Date: April 24, 2026

Project Name: UHN – Lab Histology Ventilation Upgrade
Project Number: 115625050

This Addendum shall form part of the Contract Documents and is to be read, interpreted and coordinated with all other parts. The cost of all work contained herein shall be included in the Contract sum. The following revisions supersede the information contained in the original specifications and drawings issued for the above-named project. Acknowledge receipt of this Addendum by inserting its number in the STIPULATED PRICE BID FORM.

SINGLE LINE DIAGRAMS
& MECHANICAL SCHEDULE

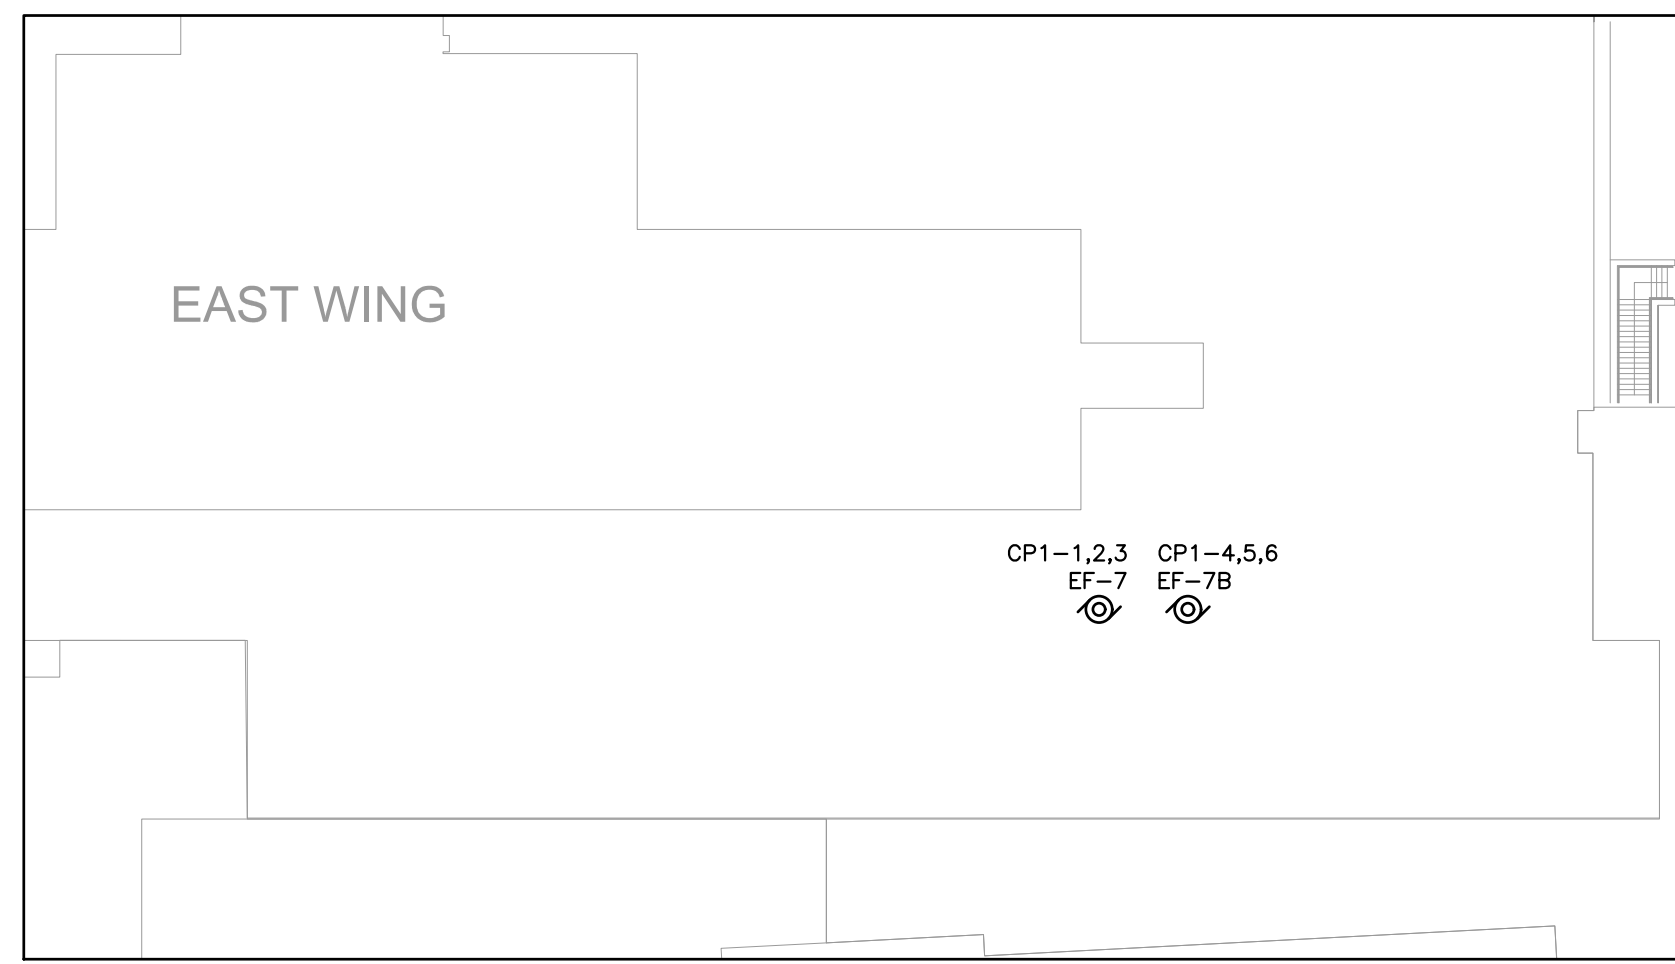
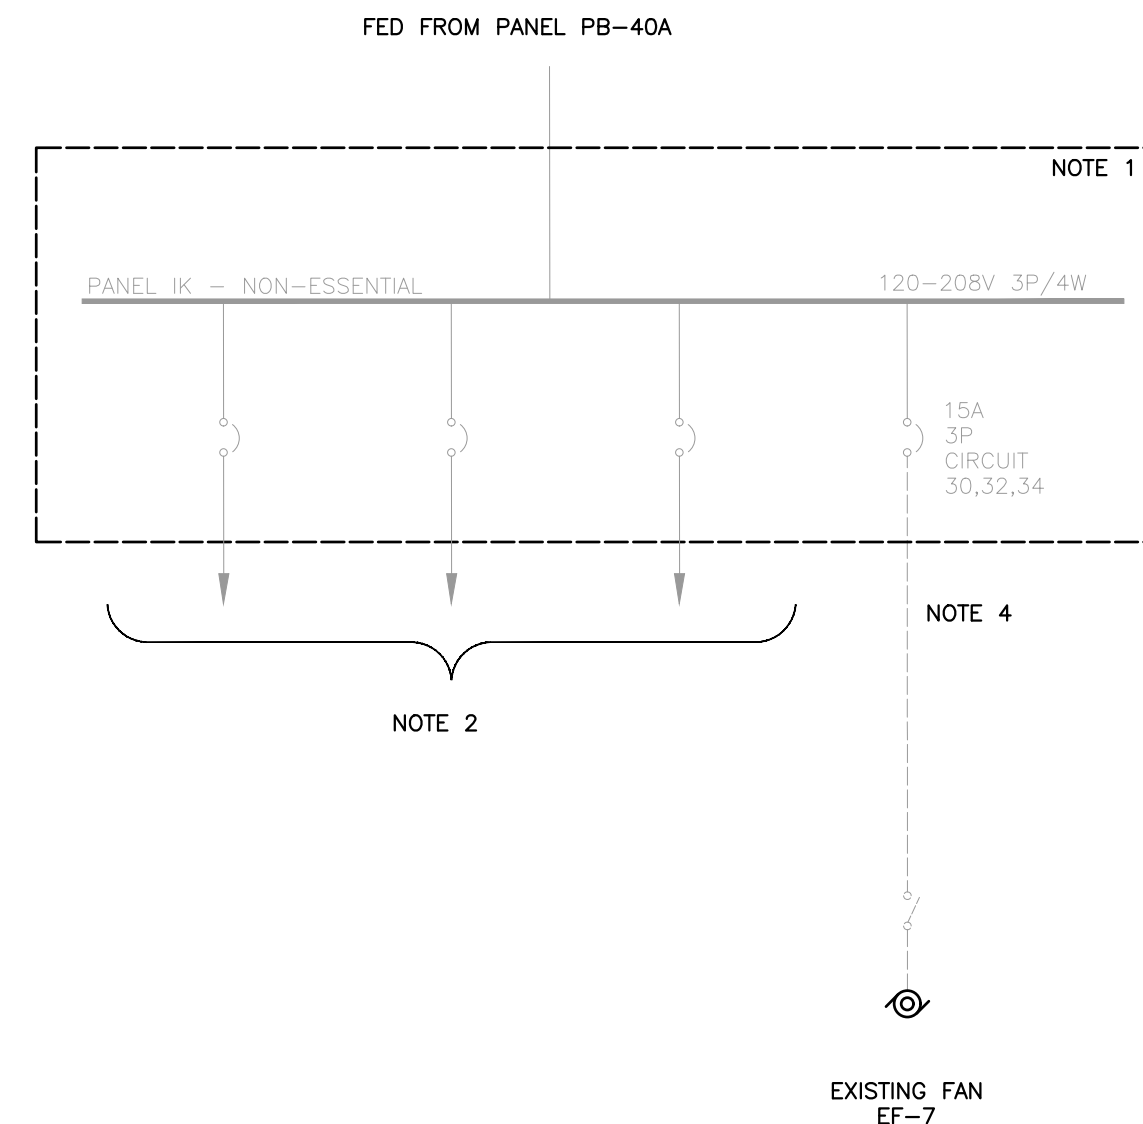
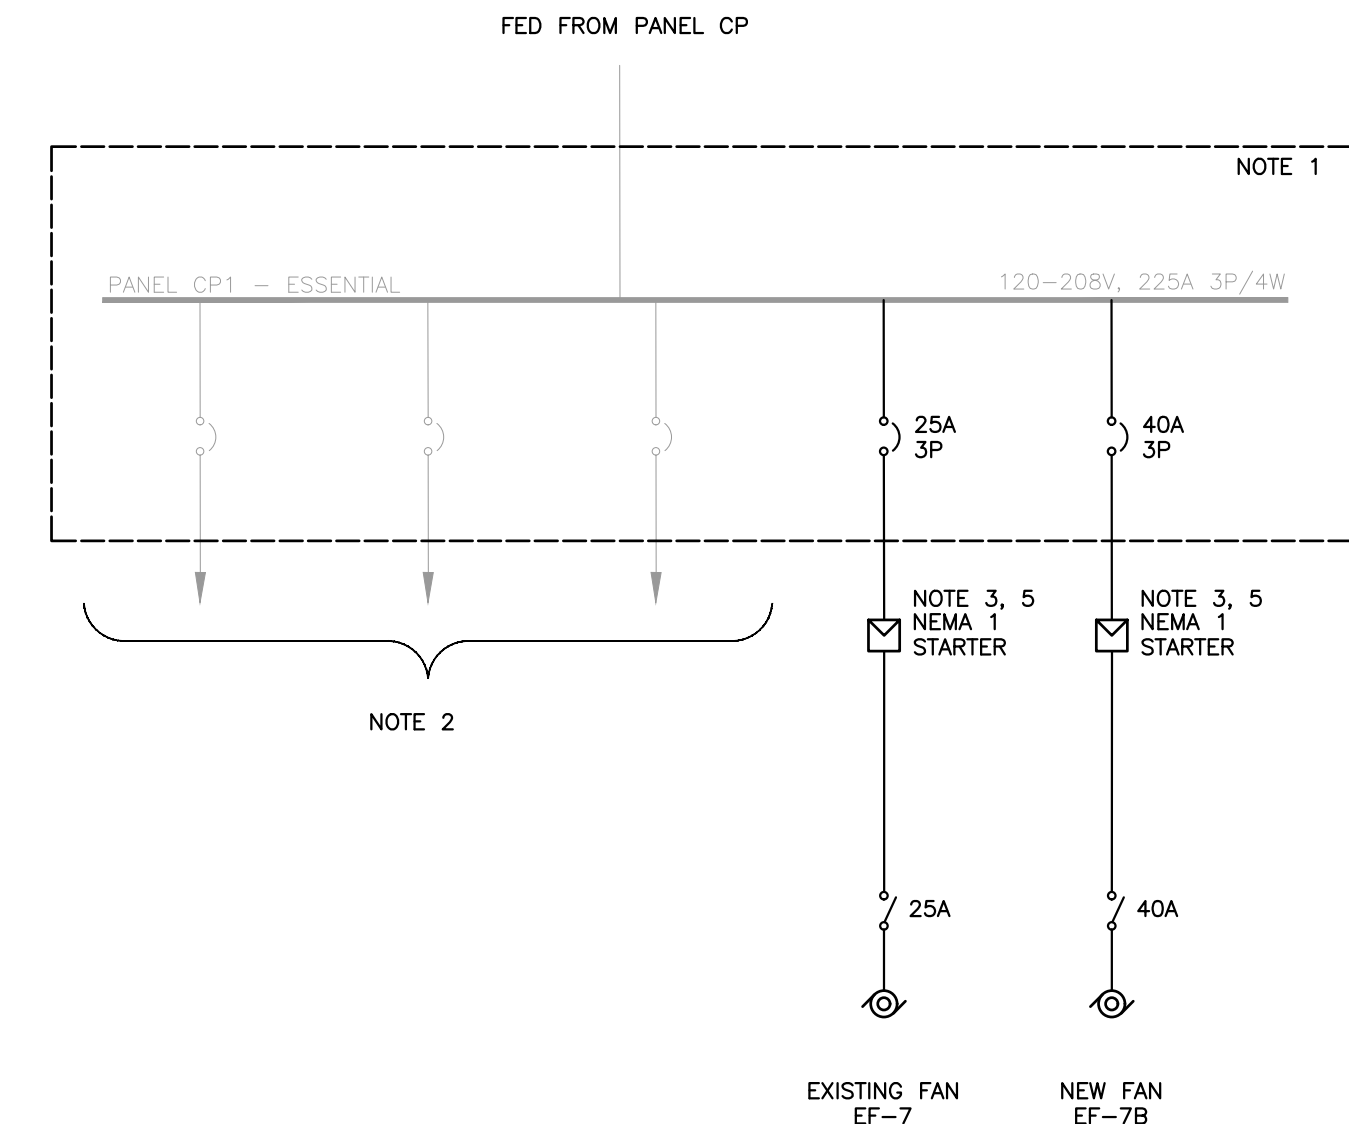
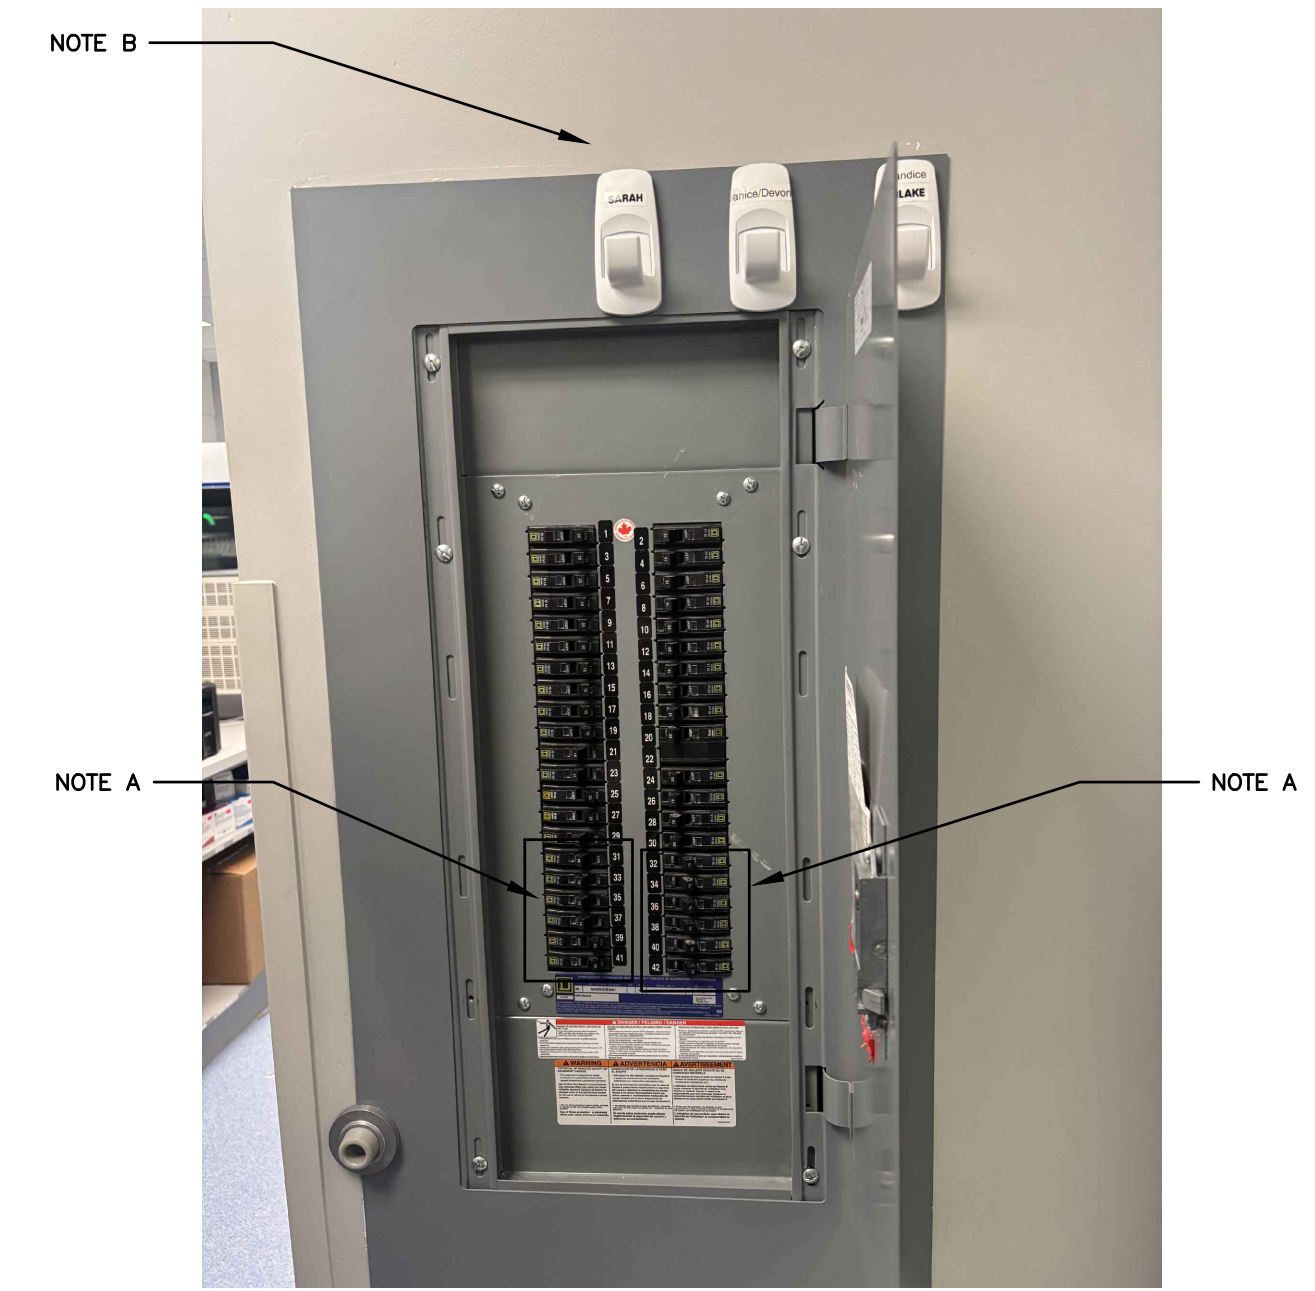
The electrical drawings are updated to capture the scope of work involving changing the power supply to the existing Histology fan EF-7 to essential electrical panel CP1 and adding power supply to new fan EF-7B (standby) from panel CP1.

Please find attached drawings E-101 Ground Floor – Histology Scope of Work Plan and E-103 Single Line Diagram & Mechanical Schedule.
